S/UNI-622-POS REFERENCE DESIGN ERRATA

PM5357

REFERENCE DESIGN ERRATA

ISSUE 1: DECEMBER 2000

Figure 1: Trace Impedance Correction

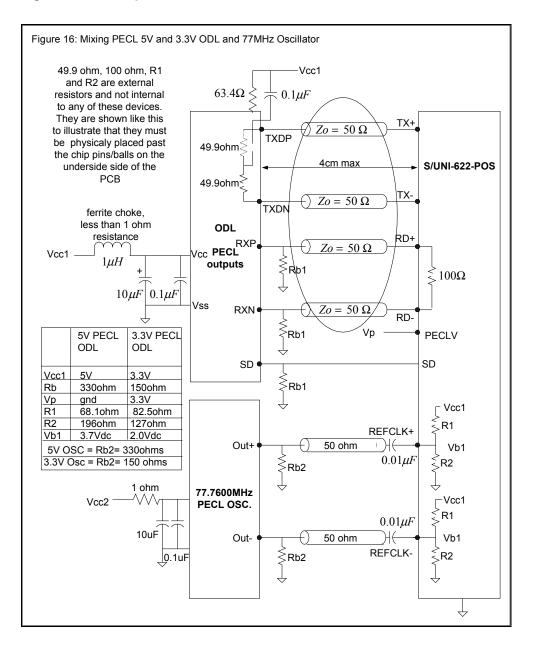
2.1 Trace Impedance should be 500hms not 100 ohms in Figure 16

The controlled trace impedance for the RXD+/- and TXD+/- were wrongly labeled as being 100 ohms each in Figure 16 of the reference design document. In Figure 1: Trace Impedance Correction, the circled traces are shown correctly as being 50 ohms each (100 ohms differential).

Figure 2: Inductor Transients may damage CMOS circuits

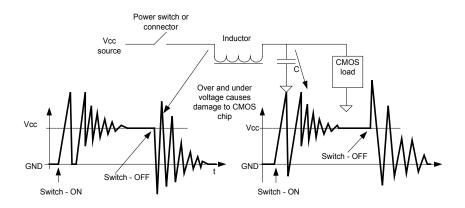
Sometimes inductors are used to filter power supplies to CMOS semiconductors and to reduce currents in hot-card insert applications. In such cases, care must be exercised to prevent damage to CMOS IC's. When power is applied to LC circuits, the ringing at the load and line side can cause voltages that exceed the chips maximum ranges and cause permanent damage to the device. Also on power down, such as hot card insertion and extraction, the voltage spikes induced by the inductor can cause permanent device damage and cause sparking at the connector/switch thus reducing component life. See figures below for more detail.

Because the LC forms a tank circuit, the resultant ringing voltage could be greater than Vcc and lower than ground on both sides of the inductor as shown in Figure 2: Inductor Transients may damage CMOS circuits.

Figure 3: Inductor Transients Clamped by Diodes

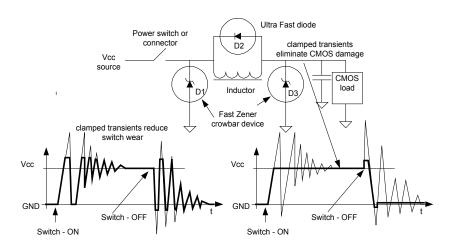
In Figure 2: Inductor Transients may damage CMOS circuits, D2 acts to commute the inductor voltage generated when power is abruptly removed from the primary side of the inductor. The voltage across the inductor is clamped by D2 to max 0.7V in the reverse direction.

D1 acts to prevent the primary side from high voltages which may cause arcing across the switch.

D3 acts to prevent the secondary side from over voltage by clamping action of the zener type device. Also, the under voltage is clamped to -0.7 V.

3.2 Connecting a TTL SD from ODL to SD PECL type input of S/UNI-622-POS

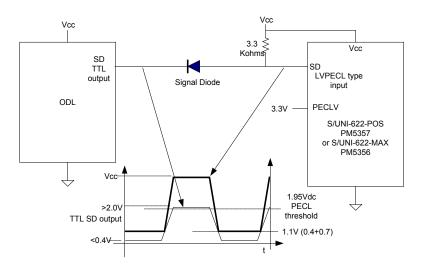
The SD input of the POS has a much bigger dynamic range than the standard true PECL receiver. Also the SD signal switches so infrequently that it can be considered as a DC signal. The figure below shows how to connect a TTL level signal to a single ended PECL input using a standard signal diode and a pullup resistor. TTL outputs typically are less than 0.4V for a low and more than 2.0V for a logic high. TTL drivers can sink a lot more current than they can source.

When the ODL's TTL SD output is low (<0.4V), current is drawn through the 3.3K resistor and the diode is forward biased. The voltage on the anode side of the diode now will be less than 1.1V (ground plus 0.4V plus the diode drop of 0.7 V). A 1.1V is lower than the 1.95V LVPECL threshold and will be recognized as a low.

When the TTL SD output switches high, theoretically its output will be greater than 2.4 V. The diode will be off and the voltage on the anode side of the diode will be higher than 2.4V+0.7V = 3.1V which is well above than 1.95V required for a LVPECL high.

Figure 5: TTL to Single ended PECL Interface

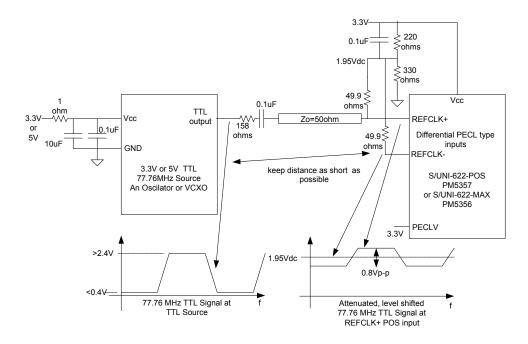
In some cases, a PECL oscillator or VCXO may be substituted for a cheaper TTL type. The circuit below will interface a single ended TTL signal to the PECL-like inputs of the S/UNI's differential REFCLK+/- inputs. Filter the power supply well to the TTL clock source as any power supply noise may frequency modulate the output. Depending on the current draw, use a small 1 ohm resistor to keep the voltage drop (IR) across the resistor as low as possible.

The TTL signal has to be attenuated from about 2.4Vdc p-p about to 0.8 Vp-p. This is done as a simple resistor divider using the 158 ohms and 49.9 ohms.

Then we have to ac couple to level shift so that the 0.8V signal is centered around 1.95Vdc, which is the sweet spot of the PECL like differential receivers of the S/UNI device.

The single ended signal is terminated into the 49.9 (50 ohm) resistor to reduce reflections and thus jitter. The REFCLK- input is biased at the mid point of the LVPECL at 1.95 V. So the input at REFCLK+ will swing above and below this voltage at REFCLK-. Do not use a TTL to PECL converter chip as it will generate too much jitter for this application.
